## **Harrison Community Club**

Accessibility Review

Transition Plan - (location/priority)

**Photo 2:** Patch the concrete to eliminate the rise at the main entry.

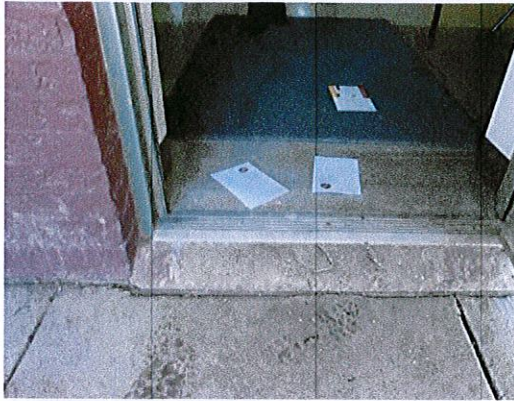
Location JQP # / Item #	Solution / Comments	Qty	Unit Cost	Total Cost	Priority	Estimated Compl. Date	Person Responsible	Actual Compl. Date	Actual Cost
<b>Coat Rack</b>									
14F4 16135	Provide a closet rod mounted no higher than 48" above the floor. ICC / ANSI 308 <i>Currently at 56".</i>	1	\$100	\$100	4				
<b>Corridor (to Women's Toilet Room and stairs to lower level)</b>									
20B 16136	Re-hinge / relocate door to provide needed maneuvering clearance on the latch pull side of the door. ICC / ANSI 404.2.3, Table 404.2.3.1 <i>Currently provides 2".</i>	1	\$400	\$400	4				
<b>Exterior Route</b>									
07H 16131	Modify to provide a level landing at the top of the curb ramp that is 36" minimum in length. MN1341 406.7	1	\$1,000	\$1,000	4				
<b>Main Entry</b>									
12H 16132	Bevel / replace / reset threshold so there is no abrupt rise greater than 1/2" or slope greater than 1:2. ICC / ANSI 404.2.4 <i>There is currently a 3" rise at the entry closest to the parking lot. A 2nd entry is accessible. Photo 2.</i>	1	\$200	\$200	4

**Photo 3:** View of kitchen. The kitchen was recently (within the last 5 years) remodeled and did not include features of accessibility.

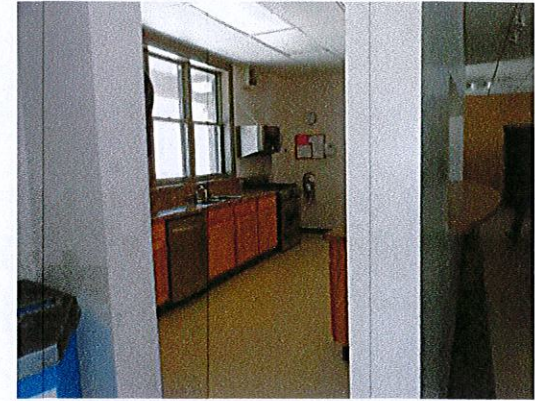
Location JQP # / Item #	Solution / Comments	Qty	Unit Cost	Total Cost	Priority	Estimated Compl. Date	Person Responsible	Actual Compl. Date	Actual Cost
<b>Kitchen</b>									
21A1 16134	Lower a minimum 36" wide section of counter to a maximum height of 36" above the floor. ICC ANSI 904.3 <i>The serving counter is currently at 42".</i>	1	\$1,000	\$1,000	3				
25J9 16133	Create an accessible kitchen, including: roll under work surface, roll under sink, range with front or side controls, and compliant clearances. ANSI 804 <i>There are currently no features of accessibility provided in the kitchen that was remodeled within the last 5 years (estimate). The counters are currently at 37". Photo 3.</i>	1	\$7,000	\$7,000	3				
				<i>Location Subtotal:</i>					\$8,000
<b>Men's Toilet Room</b>									
22B 16147	Install signage with appropriate raised and Braille lettering. MN 1341 1110.2	1	\$40	\$40	3
